Applicant: Robert H. Osborn Jr.
Application Serial No.: 10/803,642
Filing Date: March 18, 2004
Docket No.: 577-596
Page 6

REMARKS

The application has been amended. Proposed drawing changes are submitted herewith for consideration by the Examiner. Furthermore, claim 1 of the application has been amended. Reconsideration of the application is respectfully requested.

FIG. 1

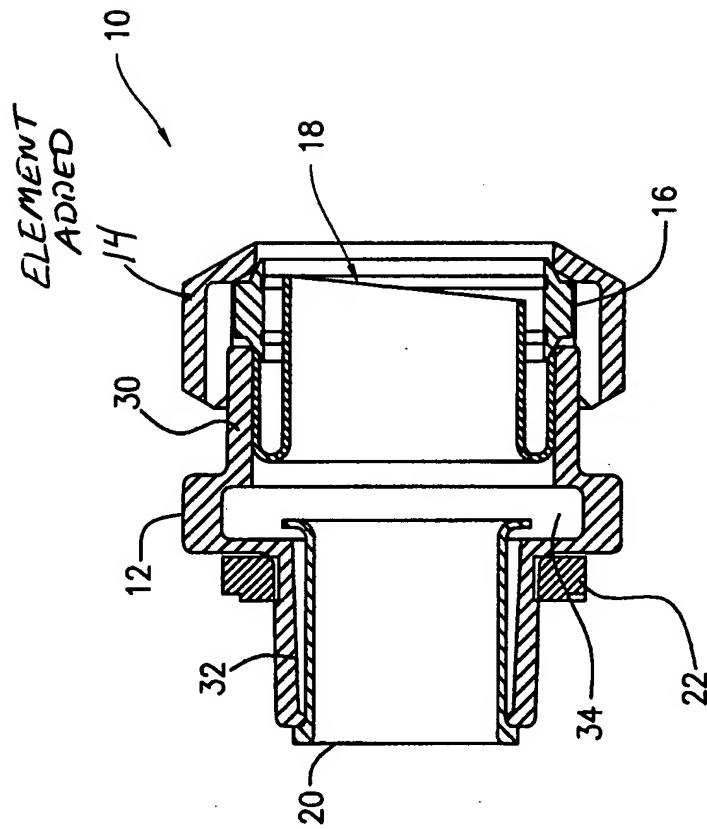
The Examiner has objected to the drawings under 35 U.S.C. §1.83(a). The Examiner contends that the gland nut as well as the sealing ring interposed between the gland nut and the body must be recited in claim 1. The Examiner suggests showing a reference numeral for the gland nut on the drawing.

The Examiner has rejected claims 1-11 under 35 U.S.C. §112, second paragraph, as being indefinite. The Examiner contends that in claim 1, line 5, "a sealing ring interposed between said gland nut and said body" is confusing because it is not shown in the drawings.

Enclosed herewith is a proposed drawing change to Figure 1. Subject to the approval of the Examiner and upon an indication of allowable subject matter, formal drawings will be prepared incorporating the proposed change. As can be seen in the attached drawing, the gland nut 14 is now properly labeled. Also as can be seen, sealing ring 16 is shown clearly interposed between gland nut 14 and body 30. It is believed that the Examiner's objection to the drawings are obviated by the proposed drawing change. Reconsideration is respectfully requested.

In view of the drawing correction submitted herewith, this determination is respectfully traversed. Reconsideration is respectfully requested.
